#### APPEAL SUMMARY

<b>Appeal ID:</b> 24413	<b>Project Address:</b> 401 N Schmeer Rd
<b>Hearing Date:</b> 11/25/20	<b>Appellant Name:</b> Daniel Reid
<b>Case No.:</b> B-017	<b>Appellant Phone:</b> 5032249560
<b>Appeal Type:</b> Building	<b>Plans Examiner/Inspector:</b> Renay Radke-Butts
<b>Project Type:</b> commercial	<b>Stories:</b> 1 <b>Occupancy:</b> S-1; B, A-2, A-3 (Accessory) <b>Construction Type:</b> V-B
<b>Building/Business Name:</b>	<b>Fire Sprinklers:</b> Yes - Fully-sprinklered ESFR system
<b>Appeal Involves:</b> Erection of a new structure	<b>LUR or Permit Application No.:</b> 20-174521-CO
<b>Plan Submitted Option:</b> pdf [File 1]	<b>Proposed use:</b> Warehouse & Office

**PORTLAND MEADOWS**  
PDXx-LOT C & F  
9475 N HORSESHOE AVE  
PORTLAND, OR 97217

LOT F - SITE PLAN  
1" = 60'-0"

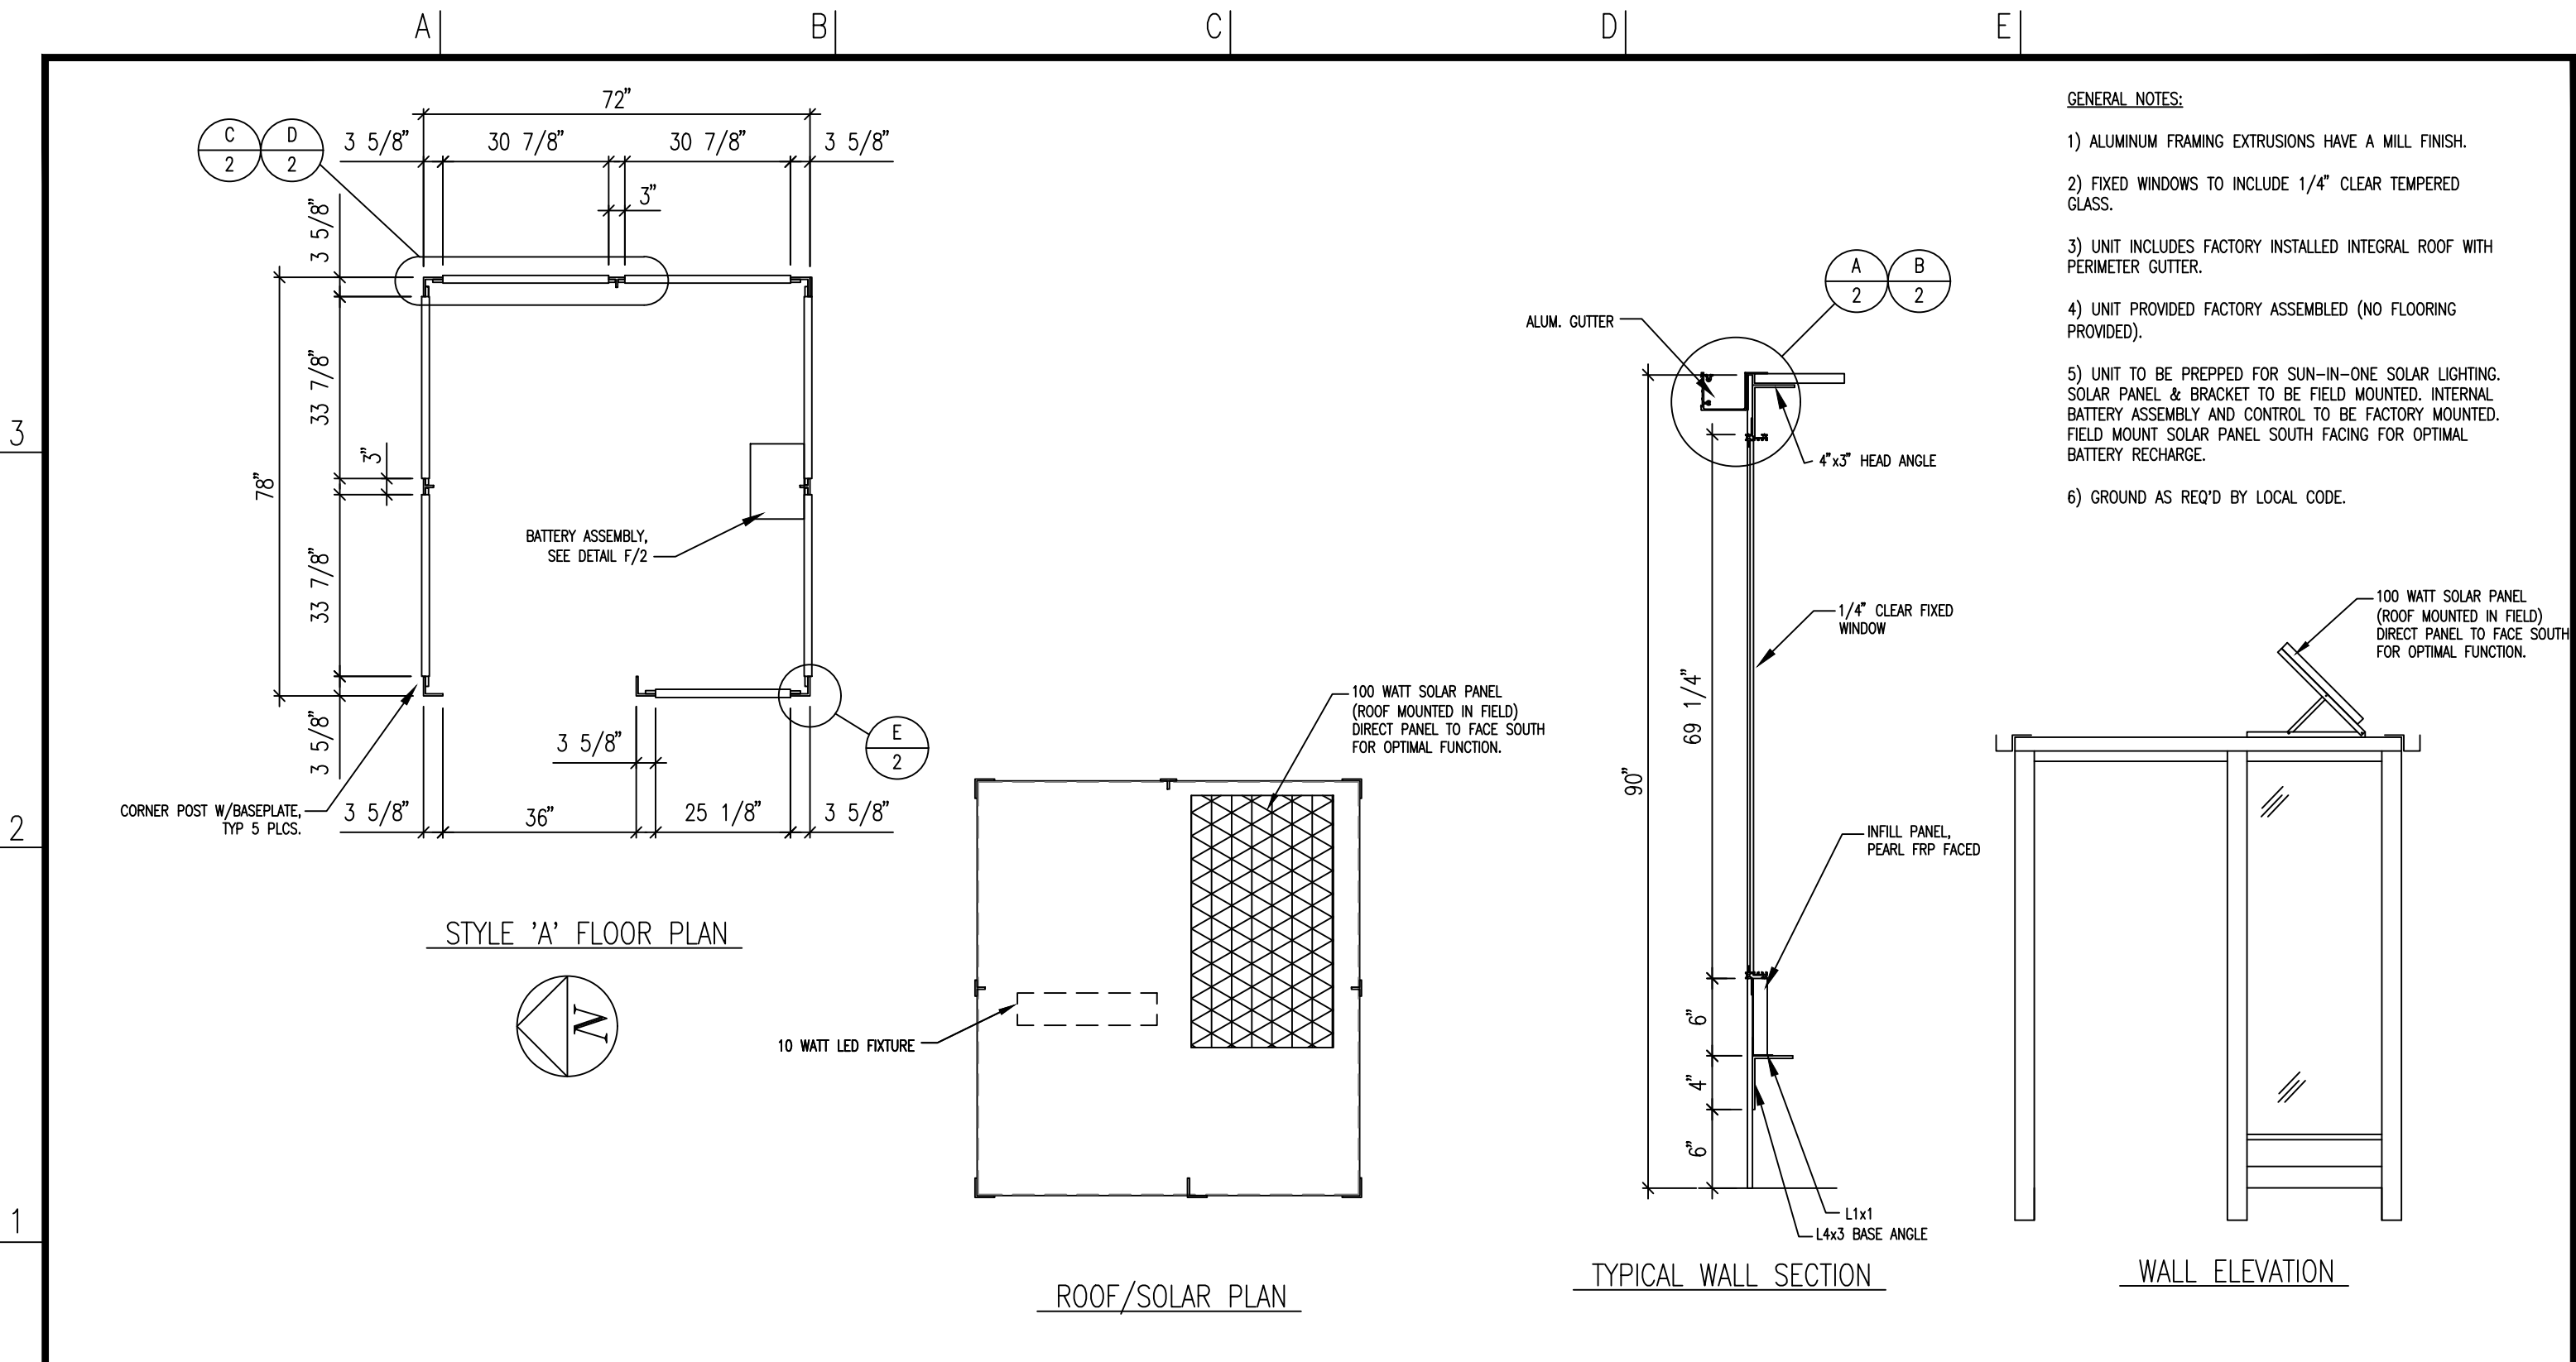
<b>Code Section</b>	2019 OSSC, Section 507.5
<b>Requires</b>	Building must incorporate automatic fire sprinkler protection throughout in accordance with §903.3.1.1 for unlimited area.
<b>Code Modification or Alternate Requested</b>	Intent of the appeal is to exempt multiple small, pre-fabricated, accessory buildings from the sprinklering requirement applied to the main building.
<b>Proposed Design</b>	<p>The proposed site plan incorporates multiple accessory buildings (not including the trash enclosure, which has a separate permit) near the main building. The main building (282,840 SF) is designed to have Unlimited Area in accordance with §507.4 in the 2019 OSSC. The main building is proposed as Construction Type V-B with S-1 and accessory B, A-2, and A-3 occupancies. The main building is constructed of concrete tilt-up panels, with glazing on accessory office portion at the south end of the building, near one of the enclosures within this appeal. Accessory buildings are generally constructed of aluminum framing with metal roof panels. Walls are predominantly glazing set in aluminum with a 6" tall skirt fabricated from Medex fiberboard with fiberglass reinforced plastic facing. The roof is metal with ceiling panels adhered below which are vinyl coated for appearance and weather-resistance. All accessory buildings are constructed similarly – see attached cut sheets.</p> <p>OSSC §503.1.2 states that buildings on the same lot shall be regulated as separate structures or shall be considered as portions of one building for purposes of identifying allowable building area and height in accordance with Table 503. We wish to include the pre-fabricated accessory buildings as part of the main building for purposes of establishing allowable area and simplification of the permitting process. However, due to configuration and location relative to the main building and site utilities, sprinklering of the accessory buildings is impractical.</p>

Three smoking shelters (6'x6.5' enclosure) will be located within the 60'-0" yards of the main building. One Ride-Share shelter (8'x12' enclosure) will be outside the 60' yard of the main building.

<b>Reason for alternative</b>	<p>The proposed design is to allow the accessory structures to be Construction Type V-B, without automatic fire sprinklers based on the following mitigating factors:</p> <ul style="list-style-type: none"> <li>• Accessory buildings consist of a non-combustible primary structure, consistent with Type V-B construction, incorporating minor combustible materials for architectural benefit.</li> <li>• Primary building is fully sprinklered (ESFR) and consists of concrete, glass and steel construction (Type V-B)</li> <li>• Accessory buildings will include limited, if any combustible fuel load (i.e. no storage) to perform their intended purpose. Accessory buildings are located on concrete pads, so proximity to fuel loads is restricted.</li> <li>• Accessory buildings are outside of the enclosure of the main building and do not restrict movement of occupants to a safe location in the event of an emergency. Concrete pads and sidewalks are provided to facilitate circulation. All accessory buildings are occupied on a temporary basis throughout the course of business operations as a function of their intended purpose.</li> <li>• All accessory buildings are of limited area and have physical separation from the main building structure.</li> <li>• Given the small footprint and location of each accessory building, they represent only a minor obstruction to fire personnel in the event of an emergency. None is located adjacent to required exit doors or fire access doors.</li> <li>• Fire-resistive construction, such as heavy timber or gypsum board wrapping of the structure is impractical due to exterior exposure with the potential for moisture damage and susceptibility to vandalism and are not in character with the balance of the project.</li> <li>• NFPA 13 (2019) §9.3.2.3 for Exterior Projections would allow the accessory structures to be non-sprinklered and of combustible construction if they were attached to the main building so long as they do not include concealed spaces. No concealed space is present in the accessory buildings.</li> <li>• While designed to high-piled combustible storage requirements, no high-piled combustible storage will be present in the main building for the initial tenancy which requires the accessory structures. Upon lease termination, the accessory structures are anticipated to be removed to allow the building to be reutilized by another user.</li> </ul>

- 1. Omission of fire sprinkler protection of 3 prefabricated smoking shelters within the 60 foot yard of the main unlimited area building: Granted provided a minimum of 10 feet separation is maintained between the shelters and the main building.**
- 2. Reduction in calculated occupant load factor for Main Security area based on use of space: Granted provided no lounge facilities are provided and space fully maintains it's intended function as circulation / security area.**
- 3. Reduction in required number of plumbing fixtures: Hold for additional information. Appellant may contact John Butler (503 865-6427) or e-mail at [John.Butler@portlandoregon.gov](mailto:John.Butler@portlandoregon.gov) with questions.**

(G01.11)  $1/4'' = 1'-0''$

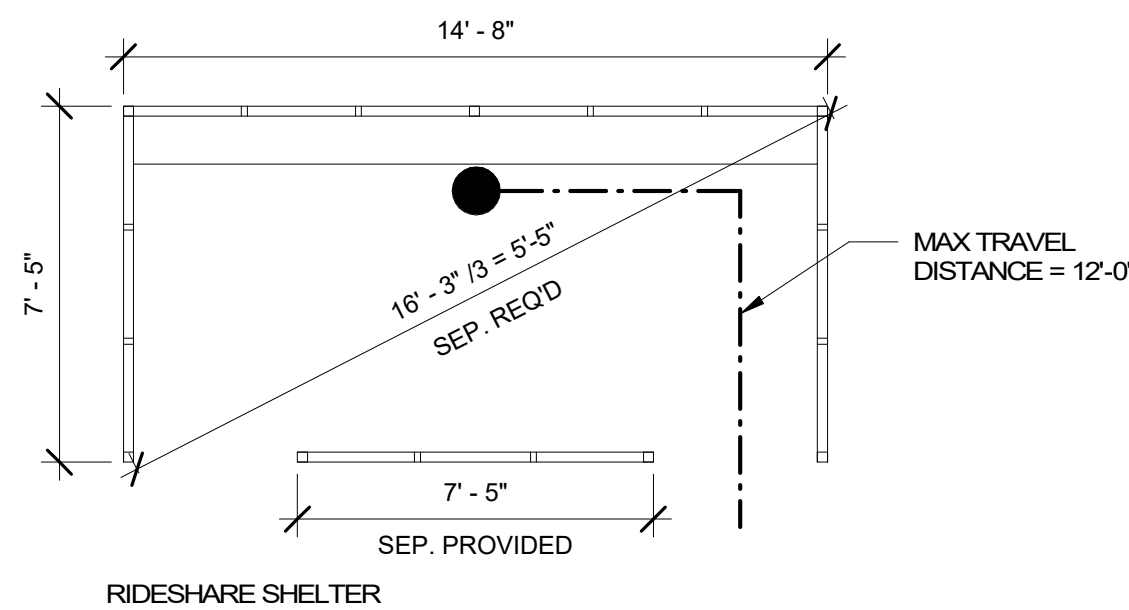
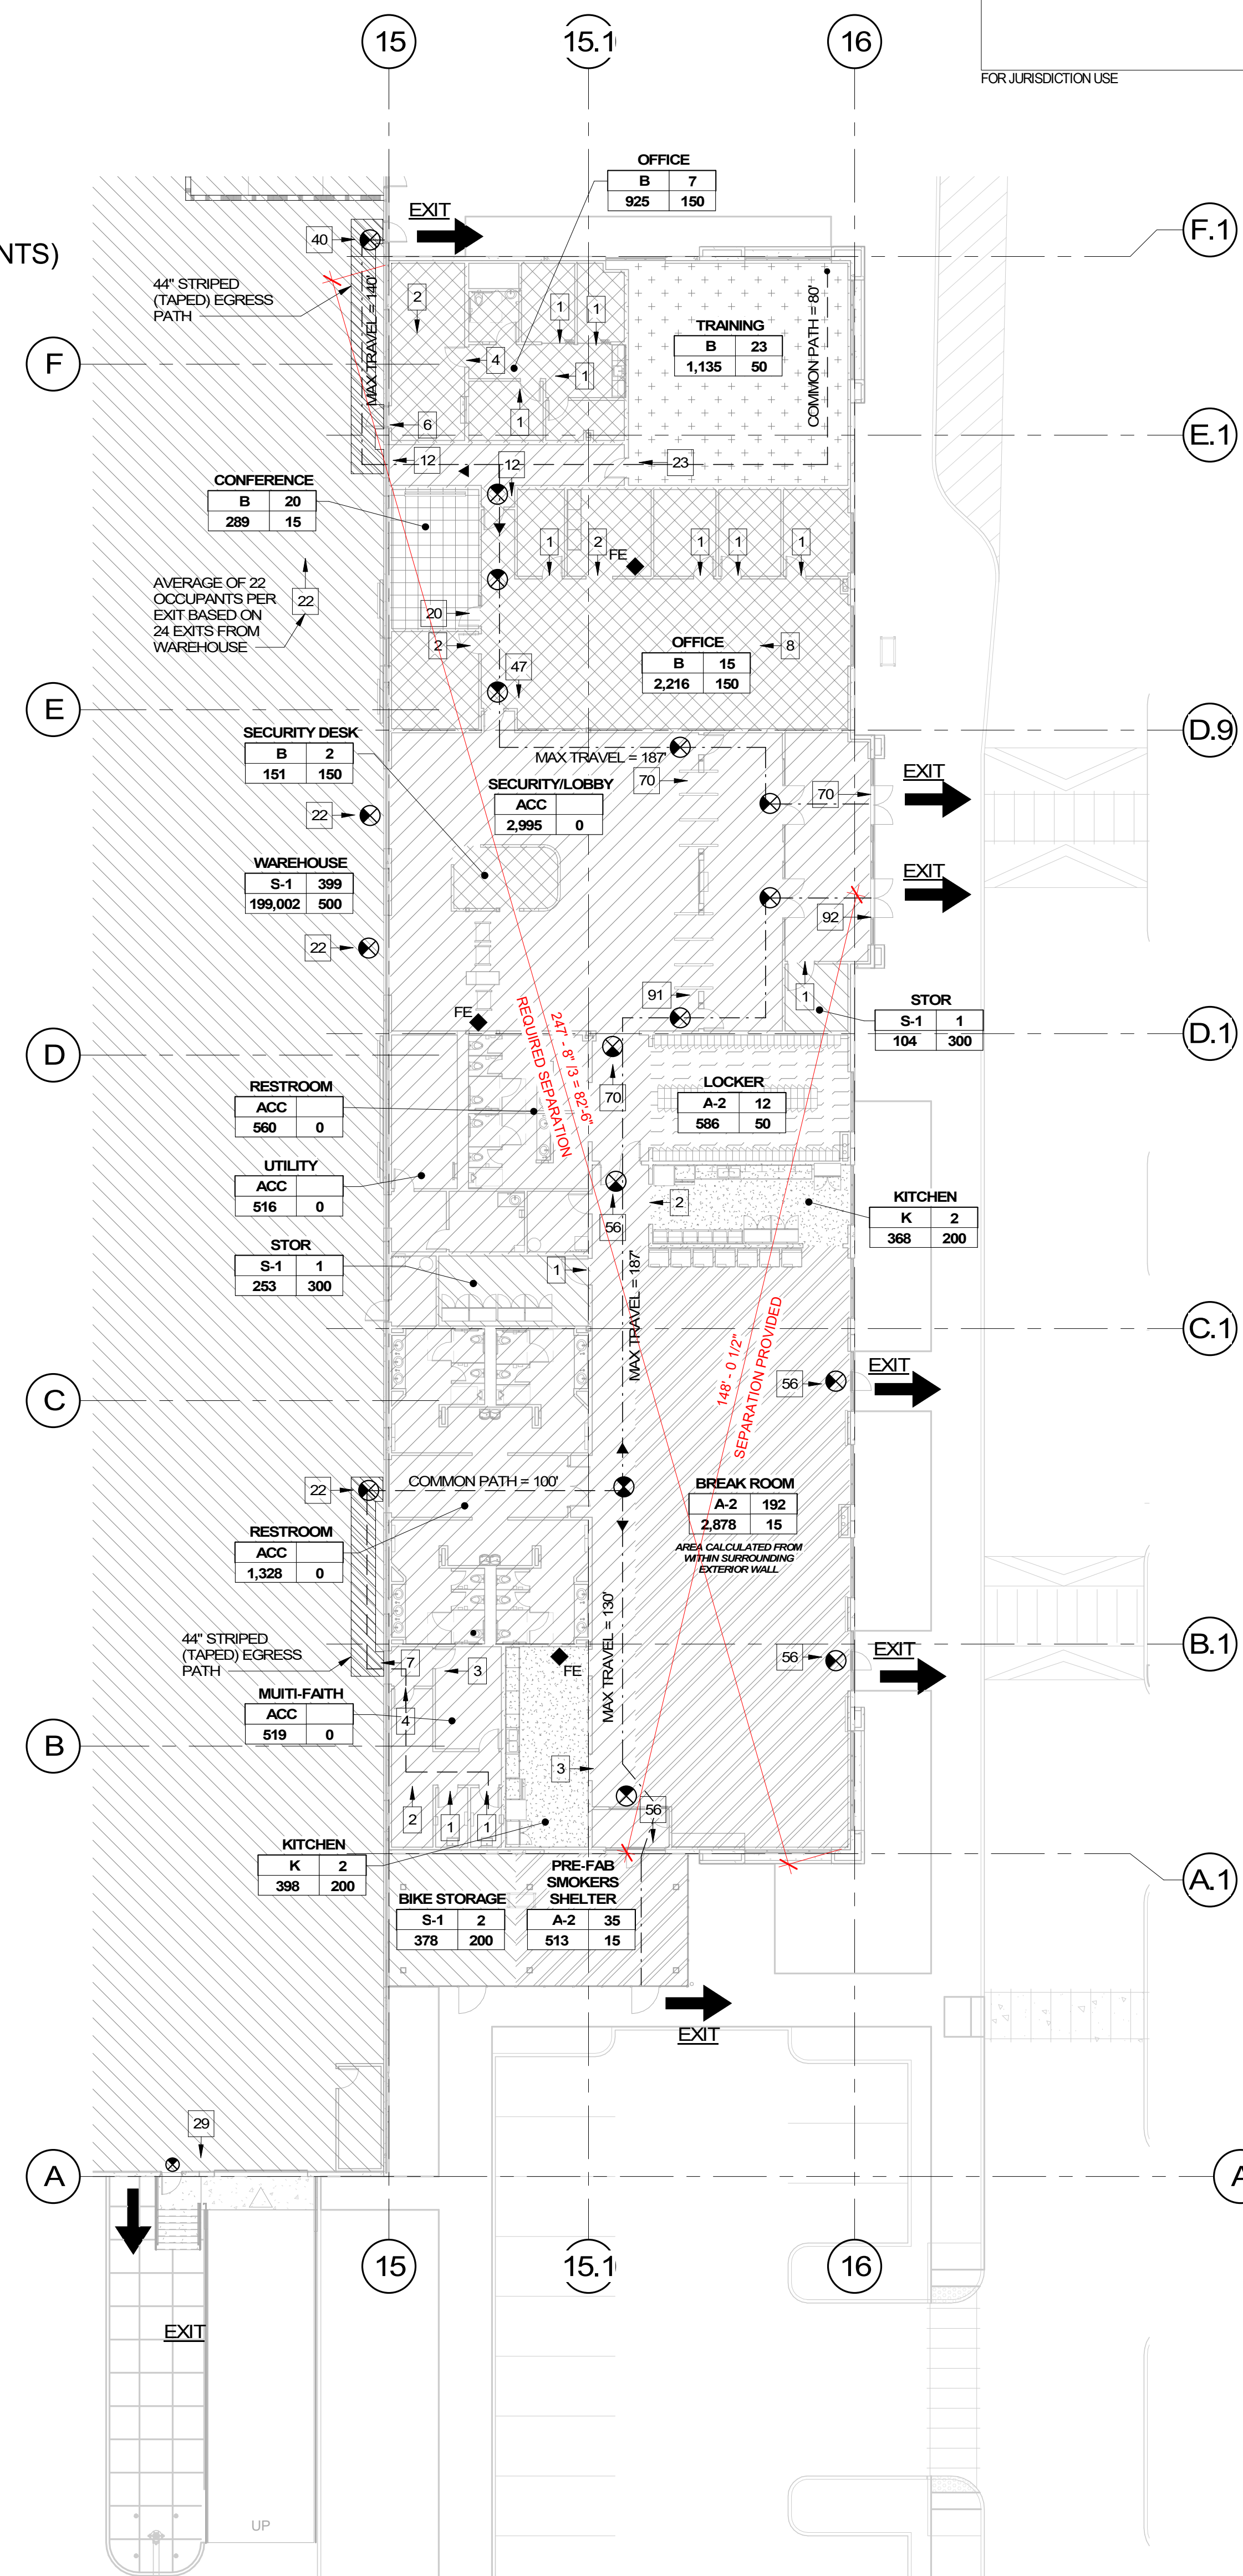
<b>Code Section</b>	2019 OSSC, Table 1004.5
<b>Requires</b>	Plan review item #133 issued on 11/13/2020 reads "Revise the following assembly area to use 1:7 OLF based on 'Assembly Standing space' Security, Security Vestibule, Weather Vestibule."
<b>Code Modification or Alternate Requested</b>	Intent of this appeal is to consider the spaces listed above to use a less intensive Occupant Load Factor due to their anticipated use.
<b>Proposed Design</b>	Propose 2,995 square feet of A-3 Assembly occupancy with an Occupant Load Factor of 1:20 (similar to an airport terminal use), yielding a calculated load of 150 occupants. The Weather Vestibule and Security Vestibule are designed as circulation spaces to provide access to the main Security area, which is also a circulation space for employee access to the adjacent Office, Locker/Break Room, and main Warehouse areas.
<b>Reason for alternative</b>	We believe that the alternative to allow for an additional 2,995 square feet of A-3 occupancy while remaining an accessory and non-separated occupancy does not affect the intent of the code limiting the aggregate area of accessory occupancies.

We believe that the alternative Occupant Load Factor of 1:20 is consistent with the proposed use as a distribution facility with 24-hour operation, multiple shifts, and employee-only access controlled by on-site Security staff. The Trip Generation report submitted in the approved Parking Adjustment (20-183310-00-LU) shows 123 peak-season, peak-hour inbound trips, including employees passing through the building entrance as well as tractor-trailer drivers entering the truck yard rather than the building entrance.

The use of the Vestibule and Security spaces are for employee circulation to and from the Warehouse, Office, Lockers, Restrooms, and Breakroom. These are not gathering areas where people will congregate.
